Subdivision and Land Development Cover  
Page for SLD # 08-25

Project Name: 604-608 Germantown Pike

**SUBJECT:** Tentative Sketch Plan Review – 604-608 Germantown Pike, Whitmarsh Township  
MCPC #21-0192-003

**RE: SLD #08-25; 604-608 Germantown Pike  
Proposed 22+ Unit Multi-Family Development (Sketch Plan)  
Zoning Ordinance Compliance Review Letter**

**CONCEPT LAYOUT 'E3'**  
 DEVELOPMENT STUDY EXHIBIT  
 606 & 608 GERMANTOWN PIKE  
 WHITE MARSH TOWNSHIP - MONTGOMERY COUNTY - PENNSYLVANIA

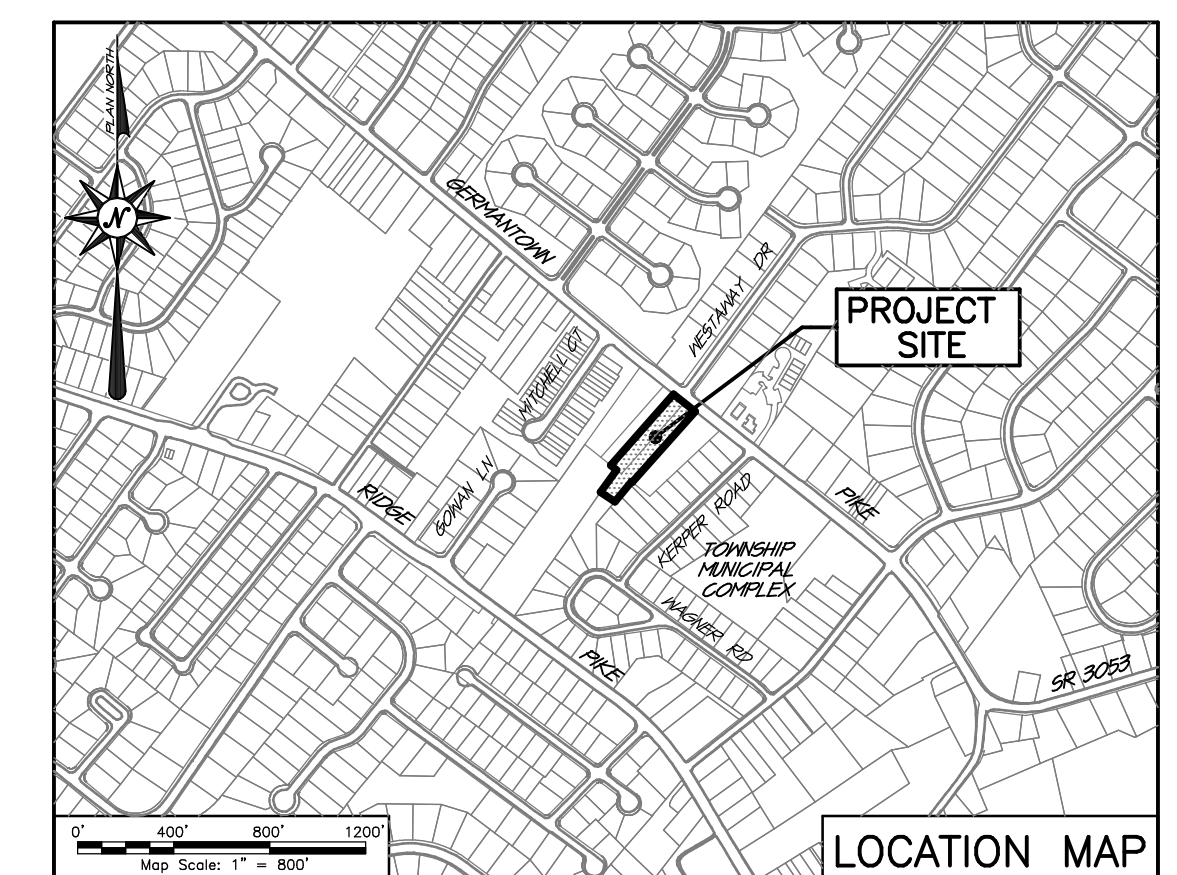
2. Pedestrian accommodations are lacking in the submitted preliminary sketch plan. As presented, the existing buildings and proposed building additions do not connect to the sidewalk along Germantown Pike, the proposed sidewalk along the entrance driveway, or the proposed sidewalk connecting to the proposed parking area. The applicant is encouraged to revise their site plan to establish additional pedestrian connections throughout the site, which will make it easier for future residents to get from their apartments to Germantown Pike and to the proposed on-site parking area.

1. Section 116-292.A requires that all conditional uses provide a shared driveway with an adjacent property, shared parking, or both. The submitted tentative sketch plan does not appear to provide shared parking. It is not clear if the proposed drive easement for 604 Germantown Pike, which is also under the applicant's control, is intended to meet the requirement for a shared driveway. The applicant is encouraged to consider additional interconnection to adjacent properties outside their control, potentially via a designed location for future interconnection (i.e., a stub street).

2. Section 116-292.C requires the provision of no less than one tree (2.5-inch caliper) per 5 parking spaces in single bays and 2 trees for every 10 parking spaces in double bays. With 22 parking spaces in double bays, four trees would be required. With 16 parking spaces in single bays, an additional three trees would be required. It is unclear if the calculation of the requirement requires rounding up or down, so an additional two trees may be required if remainders are rounded up to the nearest whole number. The required trees are recommended to be planted within and surrounding the proposed parking area.

3. Section 116-292.D states that a maximum of eight dwelling units per acre are permitted in the VC District. With 22 dwelling units on between 1.23 acres, the maximum permissible residential density is exceeded in the submitted tentative sketch plan. This inconsistency may necessitate approval of a variance by the Whitemarsh Township Zoning Hearing Board.

C. § 116-294, of Article XXXVIII, Village Commercial District. The site plan should be revised to accommodate pedestrian connections (i.e., sidewalk) between the proposed multifamily buildings on both 606 and 608 Germantown Pike and the parking area, refuse area, and to sidewalk along Germantown Pike. These additional sections of sidewalk will likely require a recalculation of the proposed impervious surfacing.

- A. § 105-39 of Article V, Design Standards. Section 105-39 requires that a minimum of one tree for every two parking spaces be provided in order to provide shade to parked vehicles. This section also requires that no less than 10% of a parking lot facility be devoted to landscaping. These requirements do not appear to have been met in the submitted tentative sketch plan.
- B. § 105-41 of Article V, Design Standards. Section 105-41 requires that a stormwater management plan be prepared for a land development. The submitted tentative sketch plan does not appear to allocate any space

3. Subsection C requires that future shared access be provided for, which is not accommodated on the submitted tentative sketch plan.
  4. Subsection G requires that a 6-foot-wide sidewalk be provided along the street line and primary accessways. The submitted tentative sketch plan lacks sidewalks on both sides of the proposed egress driveway and along one side of the proposed entrance driveway.

5. Subsection H requires that crosswalks be provided at all driveway intersections. Crosswalks are not provided for in the submitted tentative sketch plan.

6. Subsection I requires that street lighting be provided; however, no details on such has been provided.
  7. Subsection J requires that landscape buffering be provided. The submitted tentative sketch plan does not include detail on proposed landscaping.

<u>Section</u>	<u>Issue/Comment</u>
1. §116-11.	Building setback lines must be measured from the ultimate rights-of-way of streets. As defined by Section 105-30. of the Township Code (Subdivision and Land Development), Germantown Pike is a major collector with a required ultimate right-of-way of 80 feet. Section 116-11. prohibits any structure within the ultimate right-of-way unless a Hold Harmless Agreement is approved by the Board of Supervisors and recorded. While we note the proposed plans retain the existing structures, any revised plans should clearly identify the ultimate right-of-way and if there are any structures that encroach into the ultimate right-of-way, a Hold Harmless Agreement or a variance will be required.

Additionally, the Zoning and Site Data Schedule should be revised according to the ultimate right-of-way line.

5. §116-29. The applicant must obtain the approval of the Whitemarsh Township Authority with regard to the sanitary sewage needs for the project.
6. §116-184.A. The current plan shows compliance for 22 multi-family units. However, the plan does not calculate compliance for the uses located at 604 Germantown Pike, with which the parking is shared. Future plans shall be revised to clearly demonstrate compliance for all dwelling units as well as the uses on 604 Germantown Pike.

7. §116-184.D. This section requires parking areas to be separated from each other by planting strips not less than 10 feet in width. Where a double row of parking spaces is provided, a ten-foot-wide planting strip is required to separate each row. Such planting strips shall be planted and maintained with grass and/or ground cover and trees as approved by the Shade Tree Commission.

9. §116-188.3. This section is dedicated to electric vehicle charging stations. Two EV spaces are required as part of this development in addition to the minimum number of parking spaces required. A minimum of 50% of all required EV charging stations shall be ADA-accessible. Future plans shall demonstrate compliance with all subsections of this section.
